LAND USE APPLICATION COMPLETENESS REVIEW

Subject Property: 1105 Front Street NE

Reference Nos.: 24-106451-PLN (Class 3 Site Plan Review, Tentative Subdivision Plan, Class 1 & 2 Adjustment, Class 2 Driveway Approach Permit)

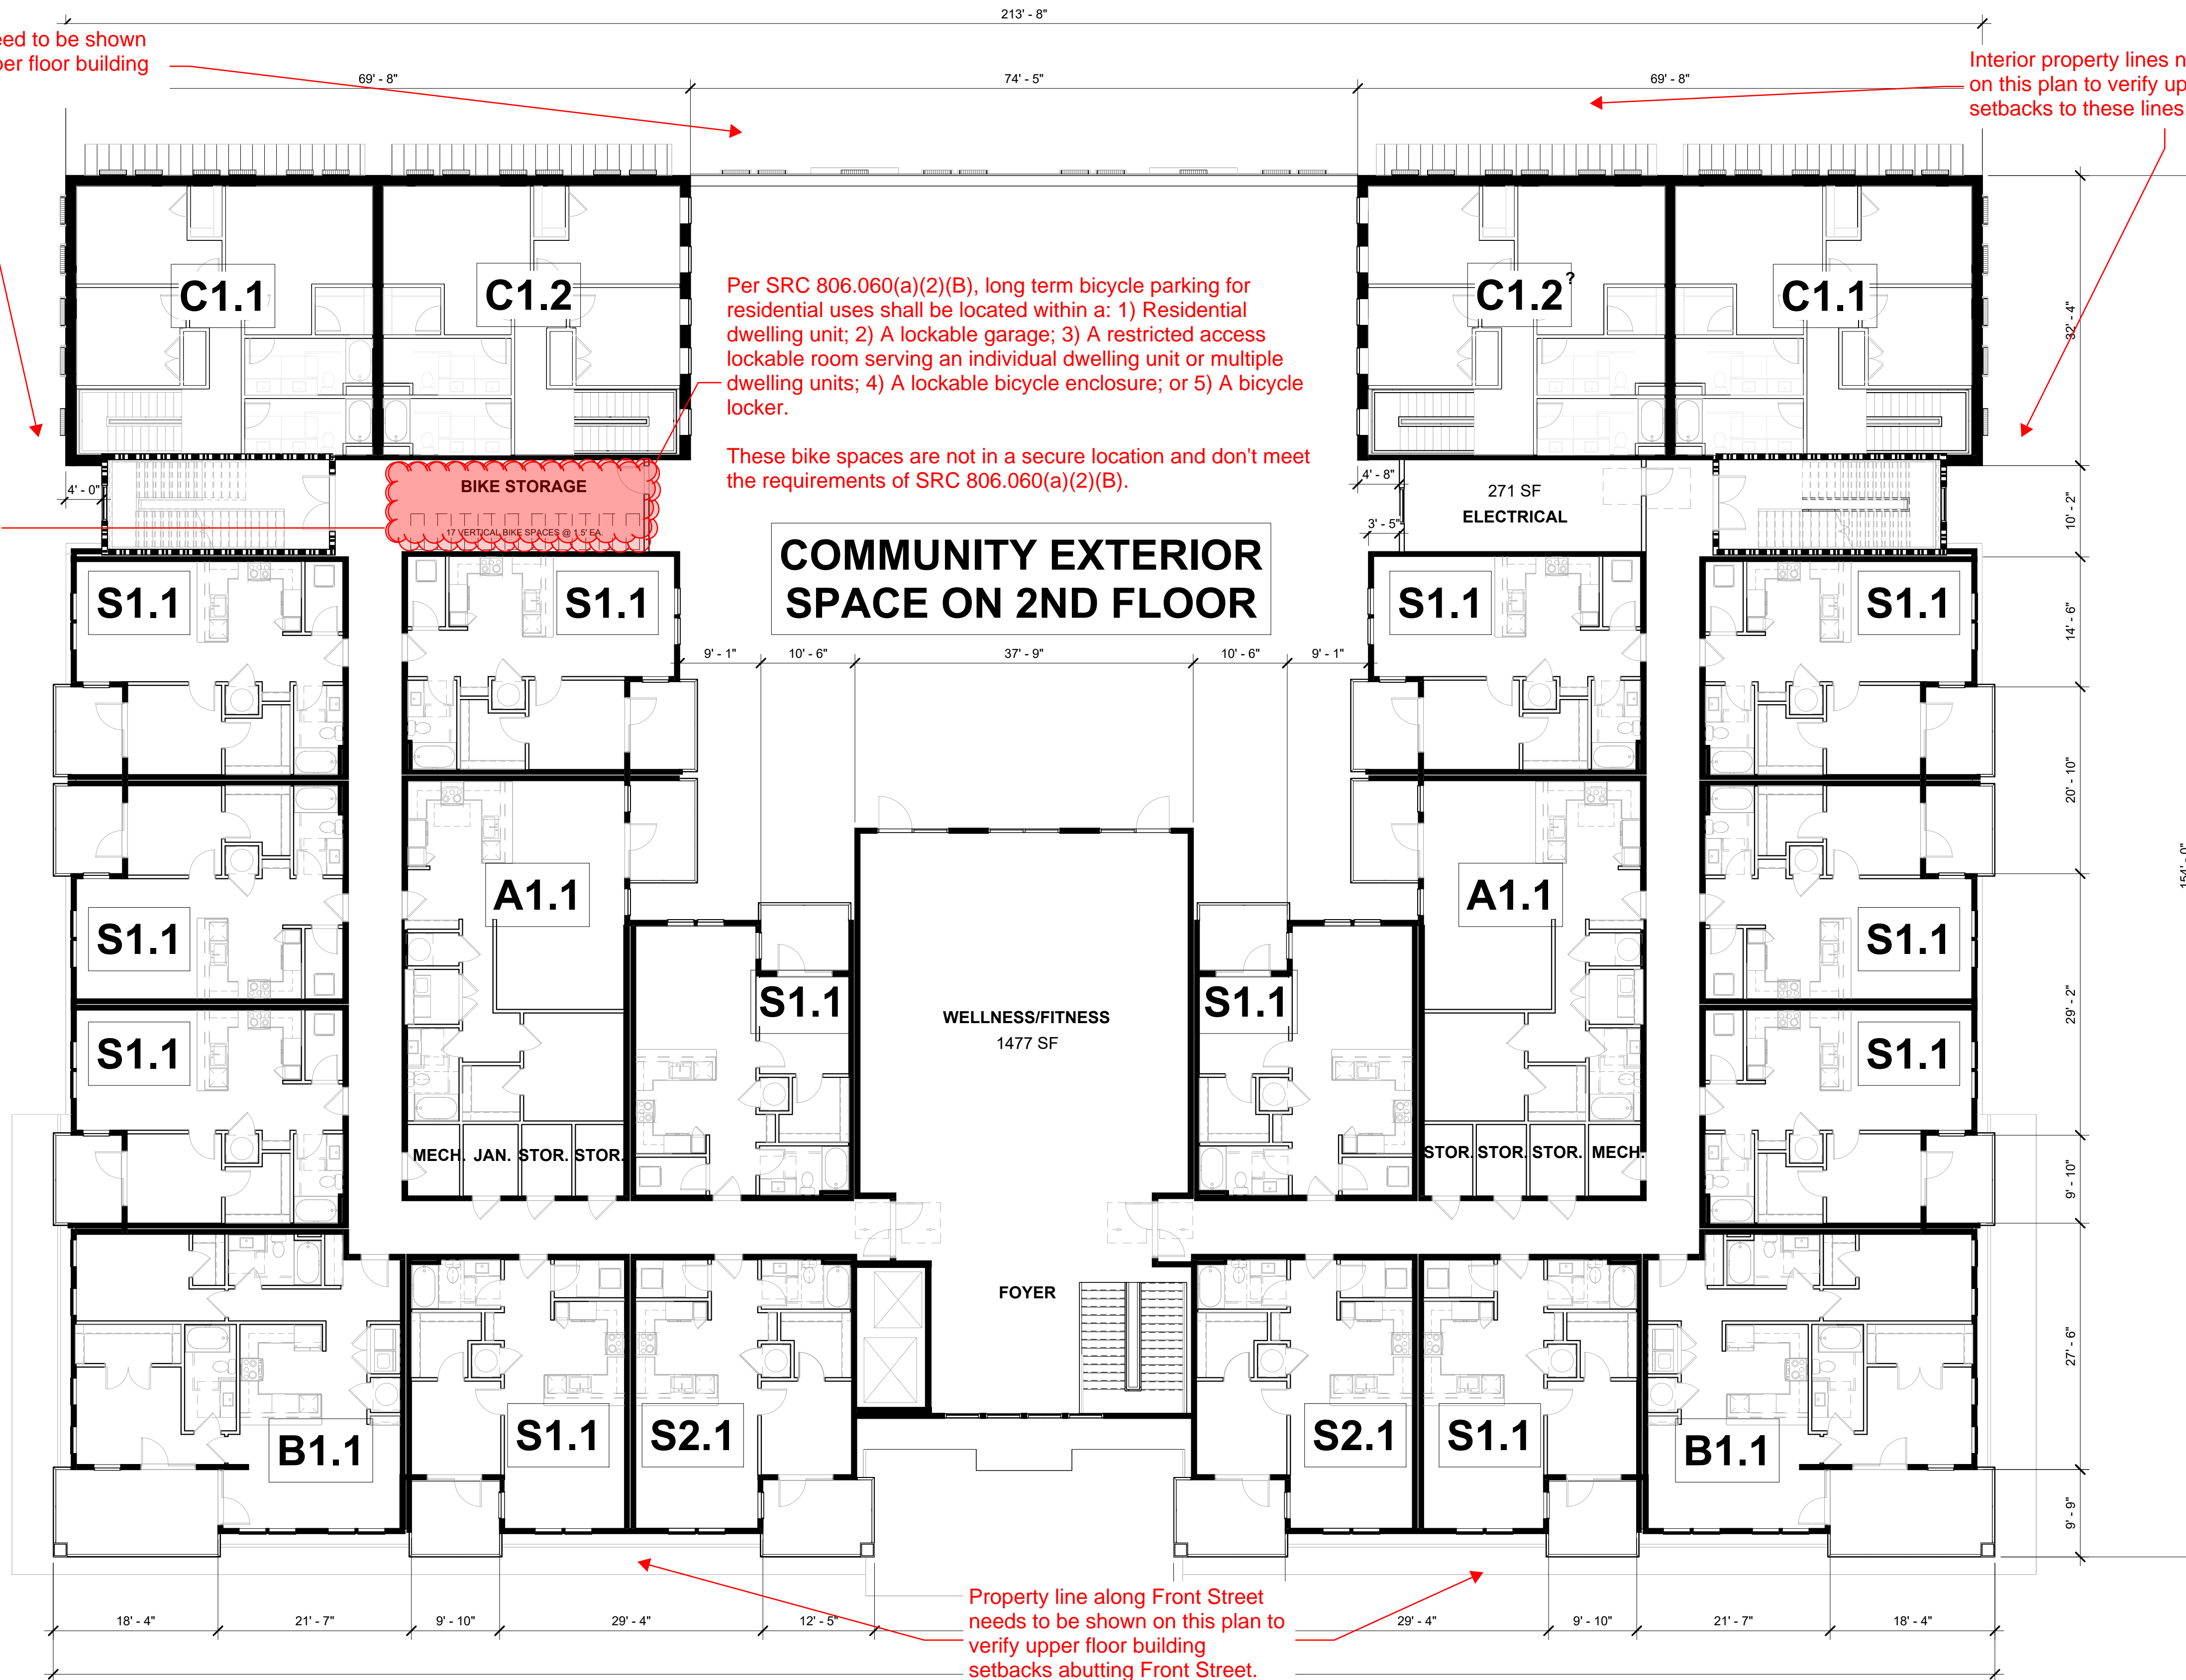
Ground Floor Building Height
 SRC 536.015(g) - Table 536-6 requires buildings with ground floors on primary streets to have a minimum ground floor height of 10 ft. For purposes of this stand ground floor height is measured from the floor to the ceiling of the first floor. The applicant's written statement indicates that the ground floor height of the building is 18 feet. However, in review of the building elevations it looks like the 18-foot height is measured from the floor of the first floor to the floor of the second floor. Confirmation is needed regarding the ground floor height of Buildings 1, 2, and 3 measured from floor to ceiling of the first floor.

Location of bike racks don't meet bike standards of SRC 806.060.

Detail drawing needed showing the layout of each bike space in relation to the proposed bike racks.

The access aisle to get to the bike spaces is located in the drive-aisle into the parking garage.

Min. 22-foot opening required for two-way driveway.

Min. 24-foot parking lot drive-aisle width required for standard size parking stalls.

Detail drawing needed showing the layout of each bike space in relation to the proposed bike racks.

Interior property lines need to be shown on this plan to verify upper floor building setbacks to these lines.

Detail drawing needed showing the layout of each bike space in relation to the proposed vertical bike racks.

Per SRC 806.060(a)(2)(B), long term bicycle parking for residential uses shall be located within a: 1) Residential dwelling unit; 2) A lockable garage; 3) A restricted access lockable room serving an individual dwelling unit or multiple dwelling units; 4) A lockable bicycle enclosure; or 5) A bicycle locker.

These bike spaces are not in a secure location and don't meet the requirements of SRC 806.060(a)(2)(B).

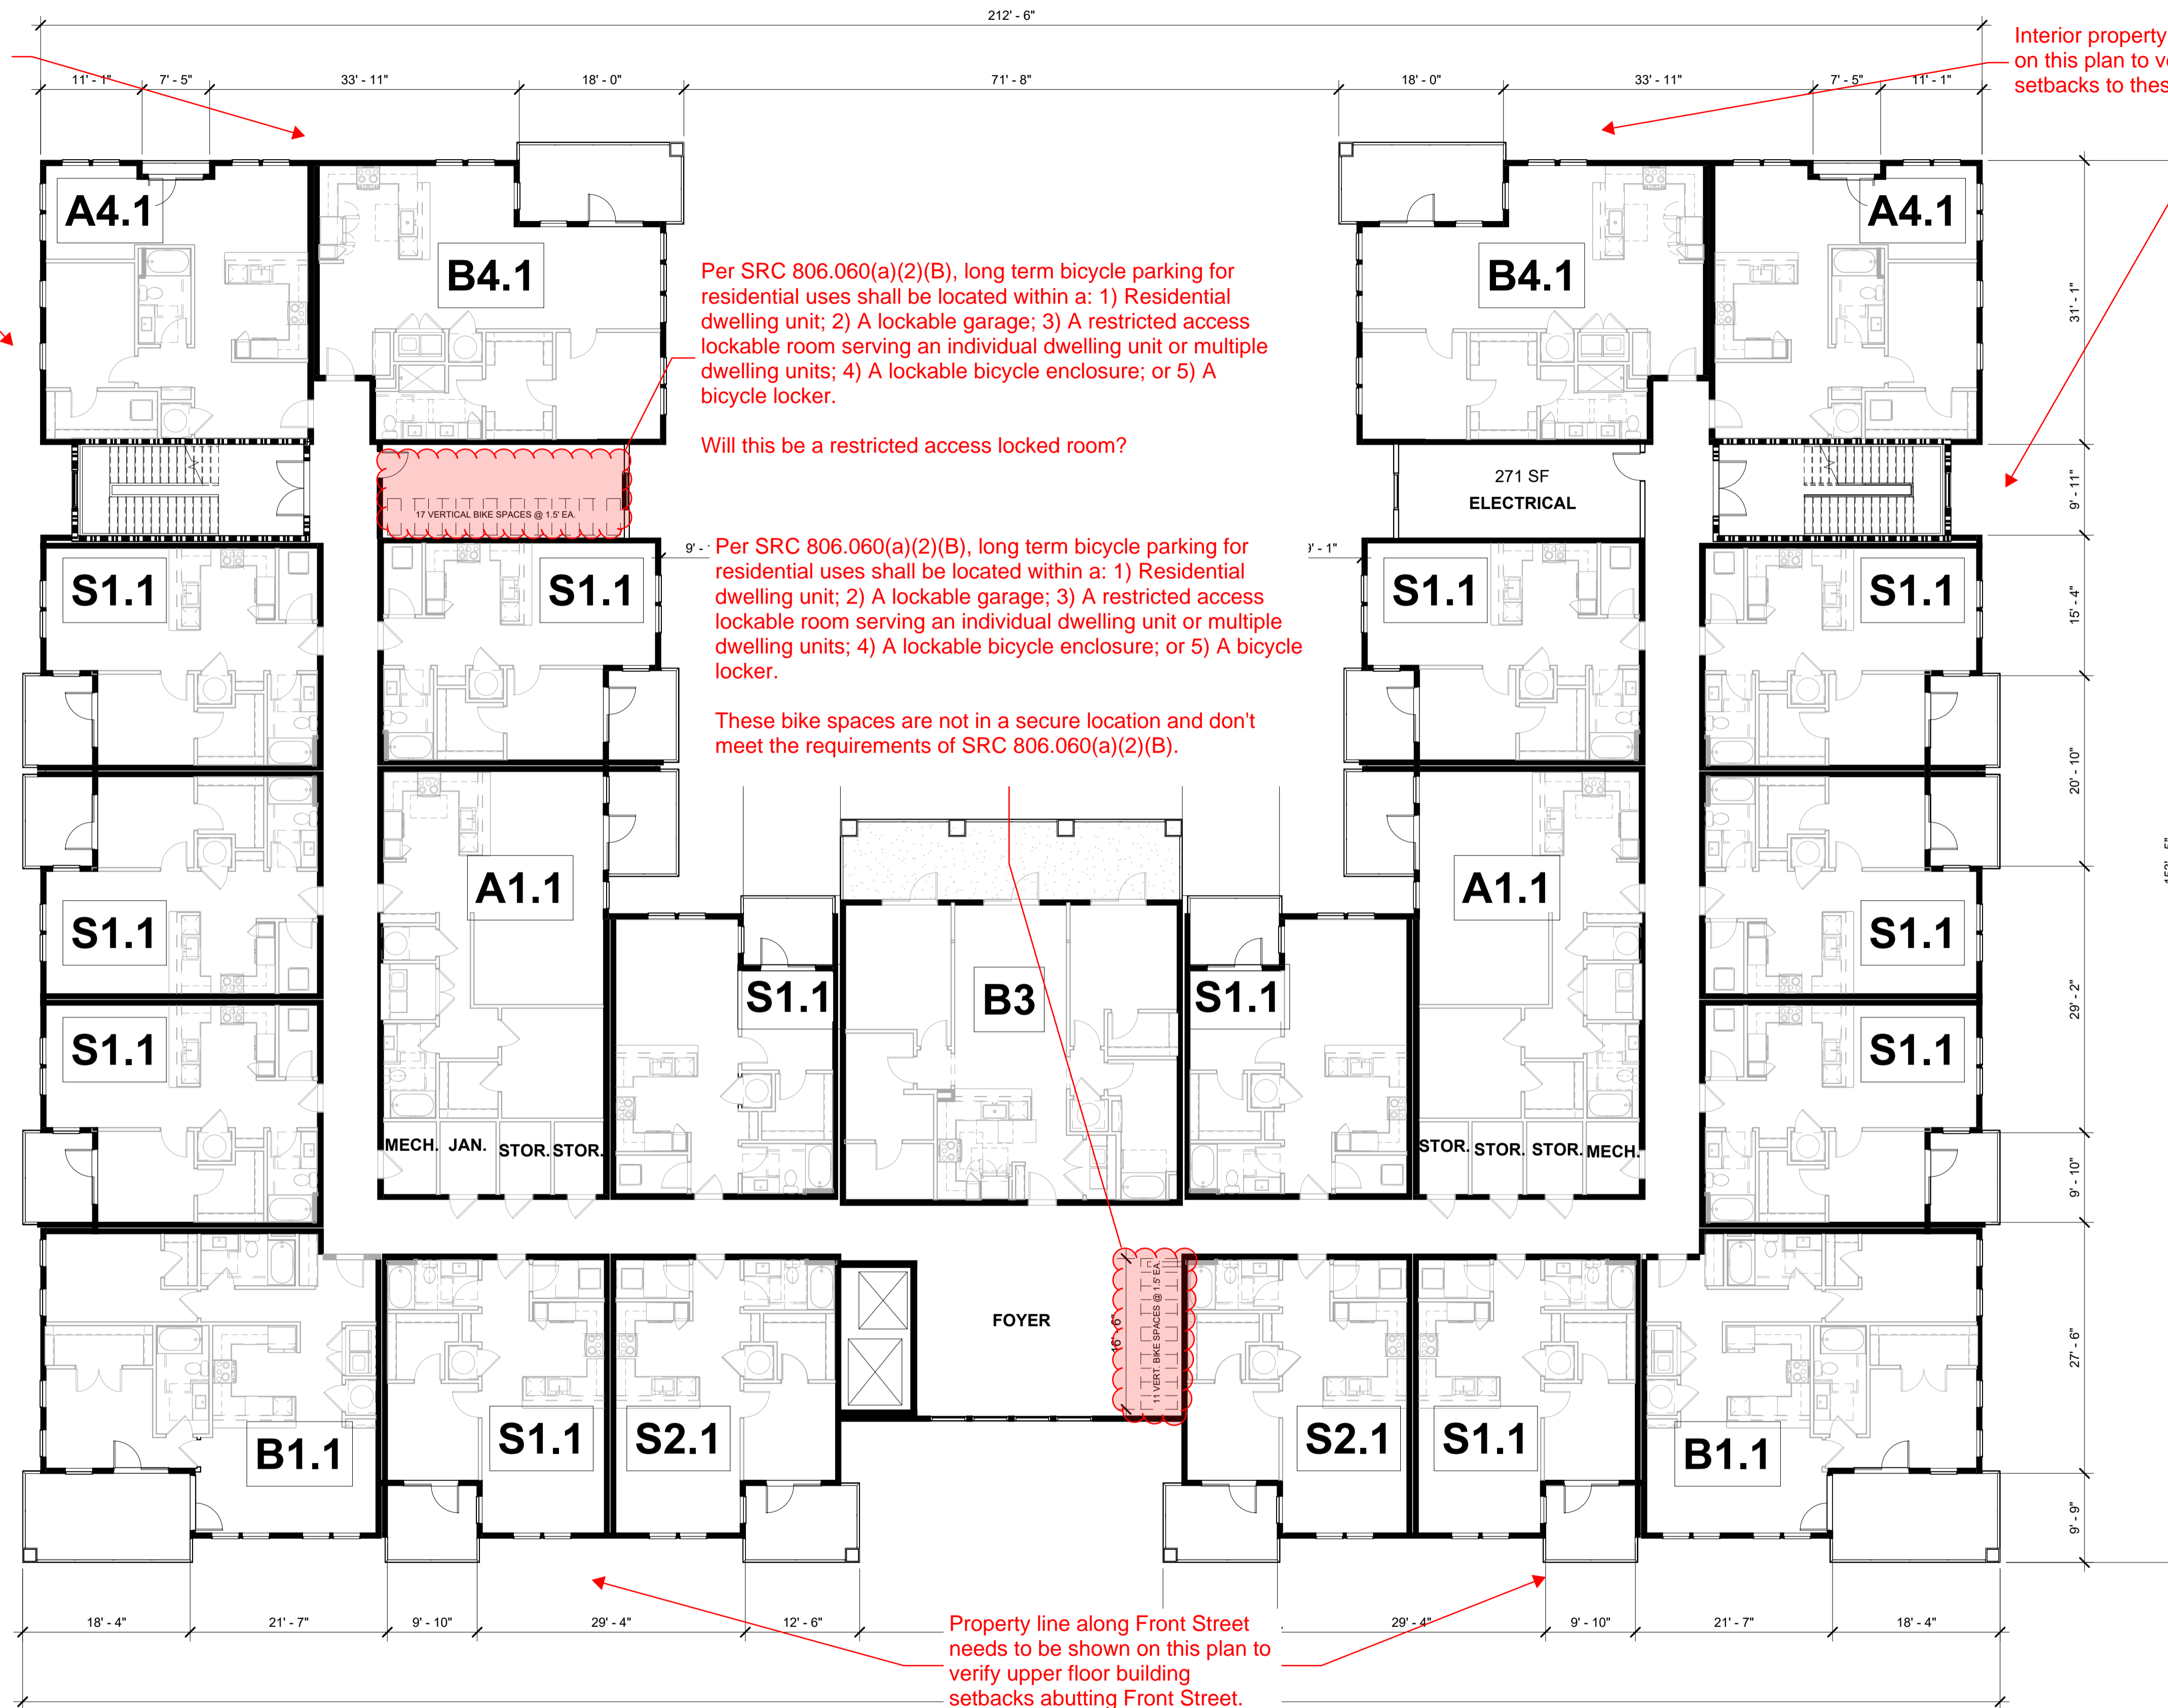
Interior property lines need to be shown on this plan to verify upper floor building setbacks to these lines.

Interior property lines need to be shown on this plan to verify upper floor building setbacks to these lines.
